# **Potomac Yard Design Advisory Committee Meeting (PYDAC)**

SUBJECT: Landbay H/I East Multifamily Proposal

As noted in the April 2017 memorandum to PYDAC (see attached), the applicant, Potomac Yard Development (PYD), is requesting approval to construct two new multifamily residential buildings at 2551 Main Line Boulevard. The project, known as Landbay H/I East Multifamily, would feature two L-shaped multifamily residential buildings measuring six stories and 69.5 and 70 feet in height. Each building would be located to either side of a central pedestrian walkway and open space. The two-level, below-grade parking garage accessible from Watson Street would contain a total of 207 spaces. The east building would contain 70 units and the west building would contain 72 units for a total of 142 units in the project.

BUILDING 2 PARTIAL NORTH ELEVATION  
Potomac Yard Landbay H Multifamily  
15.032

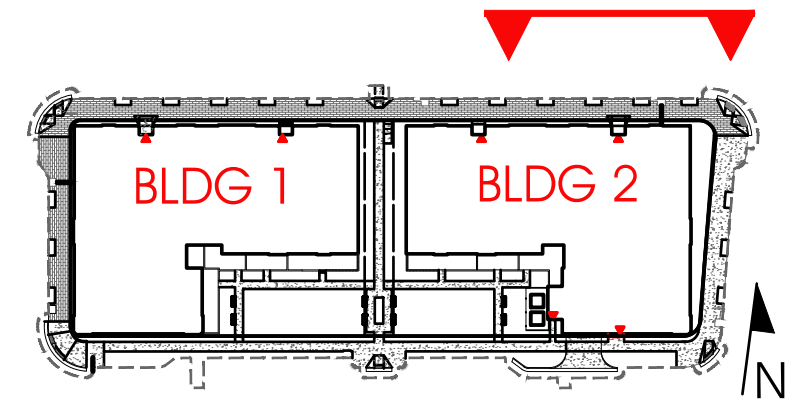
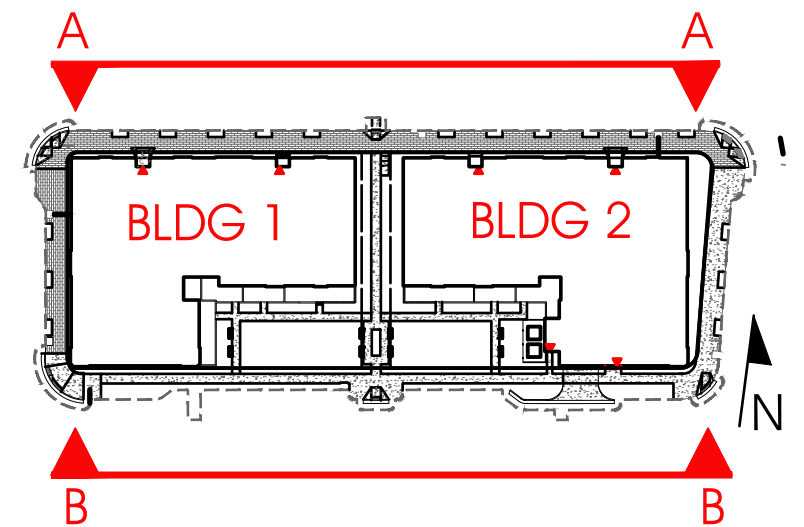
- PYDAC suggested breaking up the continuous banding at the top of the 5<sup>th</sup> floor by either dropping the cornice at the corner, or changing some of the banding in the central portion of the facades.

- PYDAC asked if the green space on site will be programed. The applicant noted that the ground level open space is designed as a passive area and would not be programed.
- PYDAC noted that the building looks a little top heavy and suggested making the striped blond base of the building appear taller. Similarly the Committee asked the applicant to consider potential changes to reduce the apparent height of the top floor also for better architectural balance.

- Increase the height of the base;
- Enhance the entry of the building;
- Reduce the apparent height of the top floor and study the appearance of the cornice; and
- Clarify the material choices at the top floor.

Following the April meeting, the applicant provided staff with updated architectural elevations addressing design-related matters. As shown in the attached images, the color of the cement panel above the front building entrance has been changed and the wall below it has been projected from the main building wall. As a result of the latter change, the cornice now also features greater detail at the corners of the front building expression. The striped brick base has been raised to improve architectural balance. The cornice has been slightly raised above new window lintels to slightly reduce the apparent height of the top floor of the building.

CORNICE AND FRIEZE RAISED ABOVE LINTELS TO DECREASE VISUAL APPEARANCE OF TOP FLOOR HEIGHT (CORNICE AND FRIEZE MATERIAL IS NOTED AS CEMENTITIOUS BOARD)

COLOR OF TOP FLOOR CHANGED TO BOTH BREAK UP TOP FLOOR AND ACCENTUATE ENTRANCE FEATURE

EXTERIOR WALL AT MAIN ENTRY IS PROJECTED TO INTERRUPT CONTINUOUS FRIEZE AND CORNICE

HEIGHT OF BASE INCREASED TO IMPROVE VISUAL BALANCE WITH TOP
